Community Solar Project Interconnection
Community Solar Project Tier 2 Review

Completed for
("Applicant")
OCS108

Proposed Interconnection
On PacifiCorp's Existing
Circuit 5P41 Killingsworth Substation

April 1, 2025

Figure 3: Distance from nearest Three-Phase Pole to Point of Interconnection

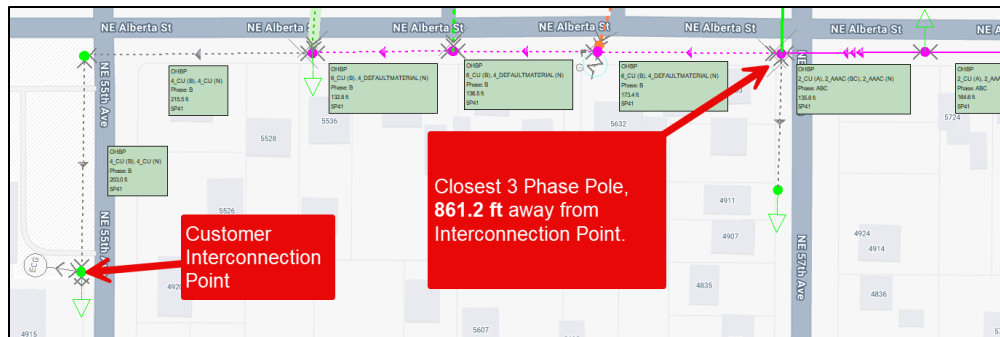
Proposed project is single-phase beyond 20 kW and with aggregated nameplate capacity of 150.93kW, will require a three-phase connection. The closest Three-Phase Point is 861 ft. upstream. See Figure 3 below in Screen 9.

Result: Fail

Substantial upgrades, including three-phase extension by 861 ft. to Public Utility's distribution lines and three-phase DC-AC conversion hardware on the Applicant's end. Three phase is not limited to 20 kW by Tier 2 Screen 7.

As the Public Utility has determined that the OCS108 interconnection request cannot be safely interconnected without additional study and facilities construction, Applicant will be required to submit a new application under the Tier 4 of Oregon Community Solar Procedures.
